Riley Purgatory Bluff Creek Watershed District Permit Application Review

Permit No: 2022-026

Project: Chapel Hill Building Expansion – Expansion of the existing school building and associated parking lot modifications. A biofiltration basin with iron-enhanced sand and underlying infiltration will provide storm water quantity, volume and quality control. The modification is to increase the building footprint by 583 square feet while increasing the stormwater facility size to account for the additional impervious area.

Reviewer: Scott Sobiech, P.E., Barr Engineering

CHAPEL HILL ACADEMY
PROPOSED

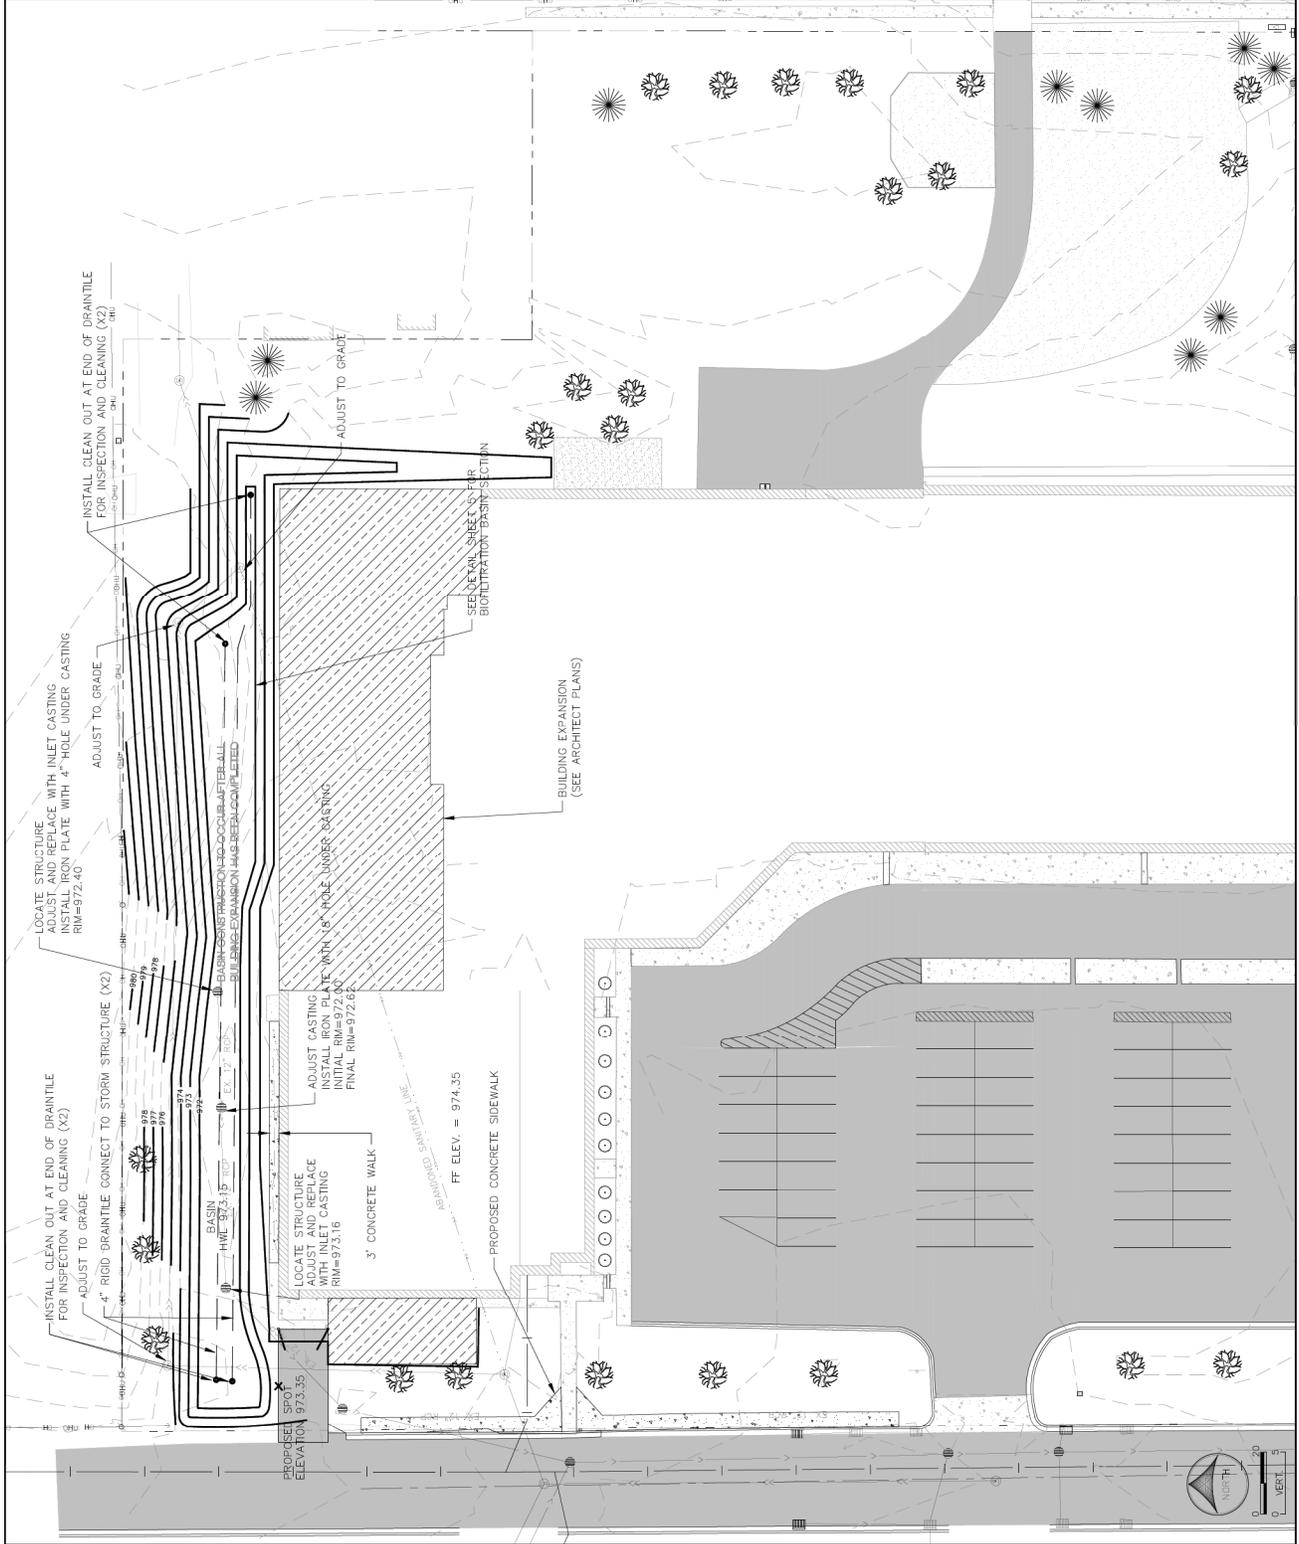
Even with the additional building expansion of 583 square feet of impervious surface the criteria listed in Subsection 3.1 only apply to the disturbed areas on the project site because the project, when considered in aggregate with prior-permitted activities at the site, increases the imperviousness by 9.6 percent and disturbs a total of 16.5 percent of the existing impervious surface on the site (Rule J, Subsection 2.3). The aggregate extent of disturbance is less than 50 percent of the impervious area of the site, and the two projects with proposed modification, in aggregate, expand the impervious area of the site by less than 50 percent, therefore RPBCWD’s stormwater management requirements apply only to the increased and disturbed and reconstructed impervious areas of the site propose for this project.

The applicant is proposing construction of a biofiltration basin with iron-enhanced sand and underlying infiltration to provide the rate control, volume abstraction and water quality management on the site. The proposed modification includes an increase in the size of the biofiltration basin to provide additional stormwater management for the added 583 square feet of impervious surface. The following table summarizes the changes to the proposes site stormwater management.

Rule	Issue	Modification Conforms to RBPCWD Rules?	Comments	
J	Stormwater Management	Rate	Yes.	Continues to meet rate control criteria.
		Volume	Yes	Because the biofiltration basin was enlarged the abstraction volume provided increased from 56 cubic feet to 63 cubic feet, thus continuing to achieve abstraction to the maximum extent practicable.
		Water Quality	Yes.	Continues to meet water quality criteria.
		Low Floor Elev.	Yes.	Continues to be low floor criteria.
		Maintenance	See comment.	The draft declaration provided on May 13, 2022 must be updated to reflect the enlarged biofiltration basin design and re-submitted to RPBCWD for review and approval prior to recording.
		Chloride Management	See comment.	No Change from conditional approval
		Wetland Protection	NA	
		M	Financial Assurance	See comment.

1. Permit applicant must provide a recorded maintenance and inspection declaration. A maintenance declaration template is available on the permits page of the RPBCWD website. (<http://www.rpbcwd.org/permits/>). The draft declaration provided on May 13, 2022 must be updated to reflect the enlarged biofiltration basin design. A draft revised declaration must be provided for District review and approval prior to recordation.

CHAPEL HILL ACADEMY
PROPOSED

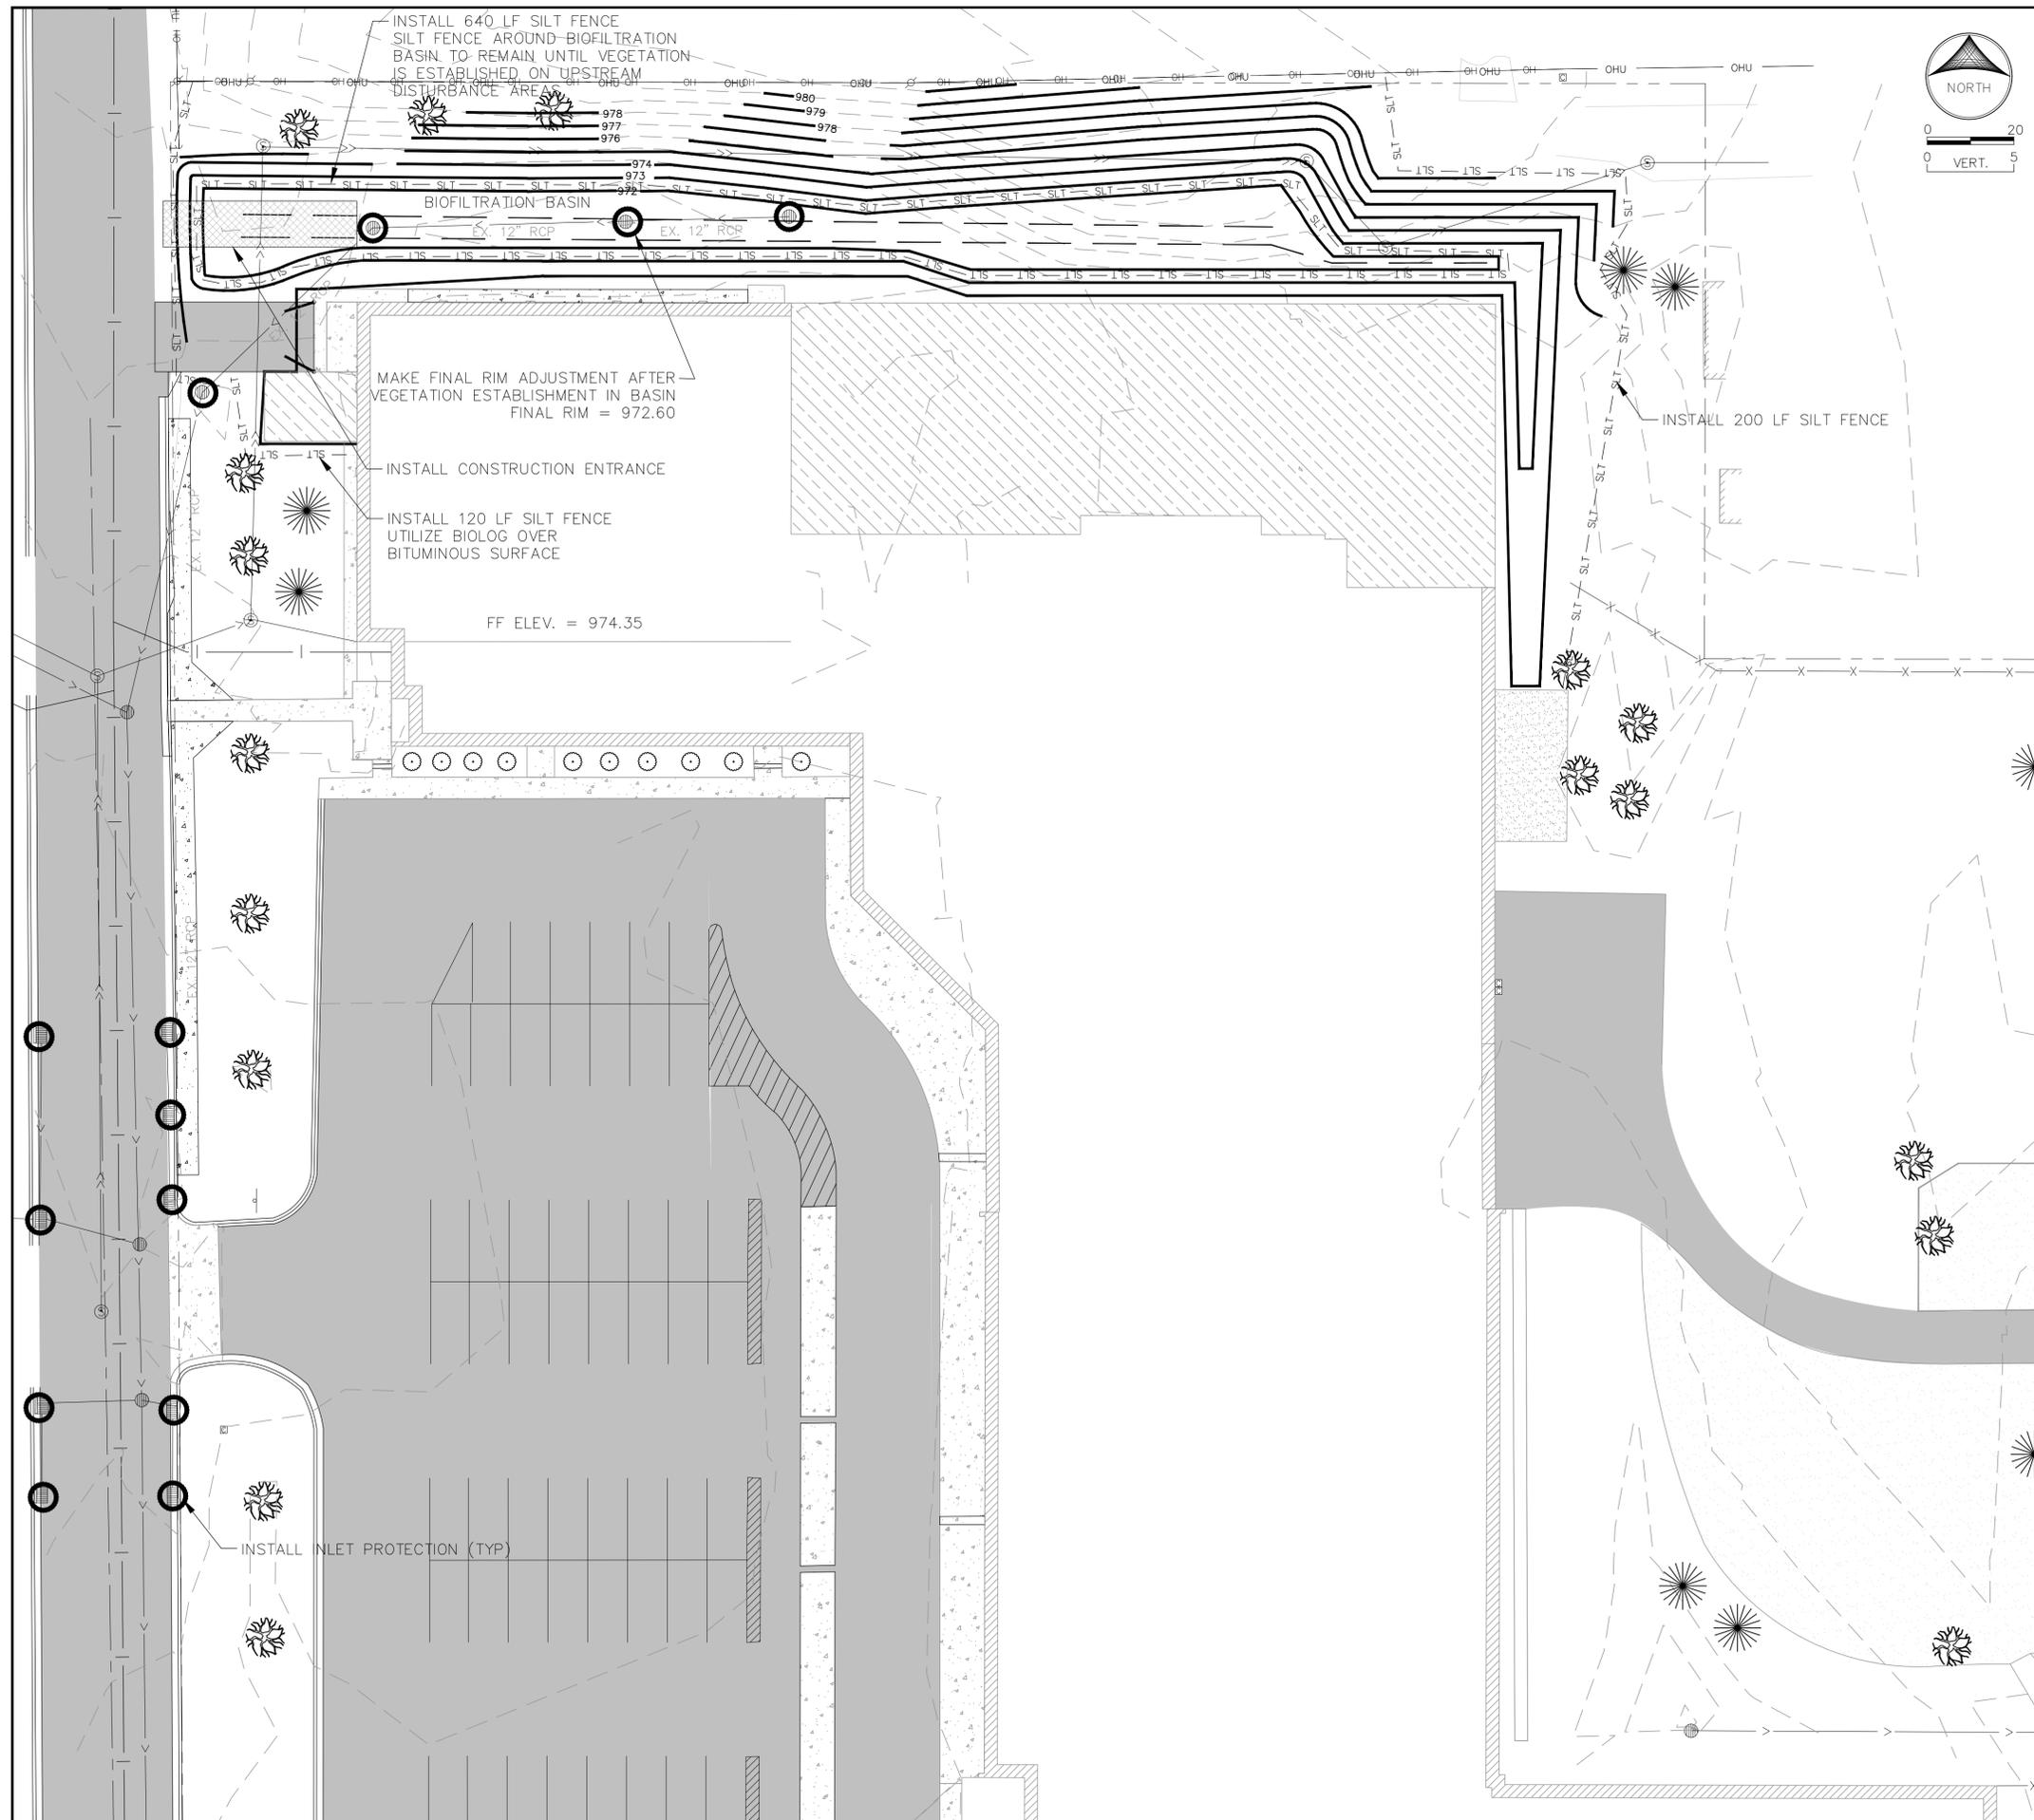
Subsection 3.1.b of Rule J requires the abstraction onsite of 1.1 inches of runoff from all new or disturbed impervious surface of the parcel. An abstraction volume of 1,797 cubic feet is required from the 0.45 acres of new and reconstructed impervious area on the site for abstraction. Pretreatment for runoff entering the biofiltration basin is being provided by grass filter strips to conform to Rule J, Subsection 3.1.b.1.

Soil borings performed by Element Materials Technology show that soils in the project area are clays. Soil borings performed by Element Materials Technology show no groundwater to a boring depth of 16-21 feet. This indicates that groundwater is at least 3 feet below the bottom of the proposed infiltration section below the biofiltration basin (Rule J, Subsection 3.1.b.2.a). Analysis by Element Materials Technology indicates that based on the encountered soil conditions and densities, the actual infiltration rates are likely in the range of 0.01-0.04 inches per hour. The Engineer concurs that soil information, existing site infrastructure and layout, and limited area of impervious surface disturbance show that the abstraction standard in Subsection 3.1 of Rule J cannot practicably be met, the site is considered a restricted site and stormwater runoff volume must be managed in accordance with Subsection 3.3 of Rule J.

For restricted sites, subsection 3.3 of Rule J requires rate control in accordance with subsection 3.1.a and that abstraction and water-quality protection be provided in accordance with the following sequence: (a) Abstraction of 0.55 inches of runoff from site impervious surface determined in accordance with paragraphs 2.3, 3.1 or 3.2, as applicable, and treatment of all runoff to the standard in paragraph 3.1c; or (b) Abstraction of runoff onsite to the maximum extent practicable and treatment of all runoff to the standard in paragraph 3.1c; or (c) Off-site abstraction and treatment in the watershed to the standards in paragraph 3.1b and 3.1c. The Applicant provided a design supporting a determination that volume abstraction is provided through the biofiltration basin to infiltrate 0.03 inches of runoff from the impervious areas on the site. An abstraction volume of 56 cubic feet is provided from the 19,602 square feet of new and disturbed impervious area on the project for volume

retention. This represents the maximum abstraction volume practicable based on site constraints. The Engineer concurs with the applicant’s evaluation of the entire property determining there were no other areas on the site that were available for the installation of volume control practices due to site grades, existing public and private utilities, mature trees and the need to maintain the school playgrounds and access routes.

The engineer concurs with the applicant’s design infiltration rates of 0.01 inches per hour for clayey soils. Based on the design infiltration rate, the engineer concurs that the biofiltration basin will draw down within 48 hours (Rule J, subsection 3.1b.3). Per Rule J, Subsection 3.1.b.2.c measured infiltration capacity of the soils at the bottom of the infiltration systems must be provided. However, the applicant has chosen to wait until construction to conduct infiltration testing. The applicant must submit documentation verifying the infiltration capacity of the soils and that the volume control capacity is calculated using the measured infiltration rate. If infiltration capacity is less than needed to conform with the volume abstraction requirement in subsection 3.3b or there is inadequate separation to groundwater, design modifications to achieve compliance with RPBCWD requirements will need to be submitted (in the form of an application for a permit modification or new permit).

Because the low floor elevation of the off-site, existing residential structure to the north of the proposed biofiltration basin is estimated to be below the 100-year flood elevation in the basin, an analysis was performed using *Appendix J1 Plot 1: Minimum Depth to Water Table for No Further Evaluation*. The result of the low floor analysis is summarized in the following table. The results demonstrate the provided separation is greater than the minimum required, thus meeting the habitable structure requirements in Rule J, Subsection 3.6b.

- J1. Permit applicant must provide a recorded maintenance and inspection declaration. A maintenance declaration template is available on the permits page of the RPBCWD website. (<http://www.rpbcwd.org/permits/>). A draft declaration must be provided for District review and approval prior to recordation.

5. Per Rule J, Subsection 3.1.b.ii measured infiltration capacity of the soils at the bottom of the biofiltration basin must be provided. The applicant must submit documentation verifying the infiltration capacity of the soils and that the volume control capacity is calculated using the measured infiltration rate. If infiltration capacity is less than needed to conform with the volume abstraction requirement in subsection 3.3b, design modifications to achieve compliance with RPBCWD requirements will need to be submitted (in the form of an application for a permit modification or new permit).
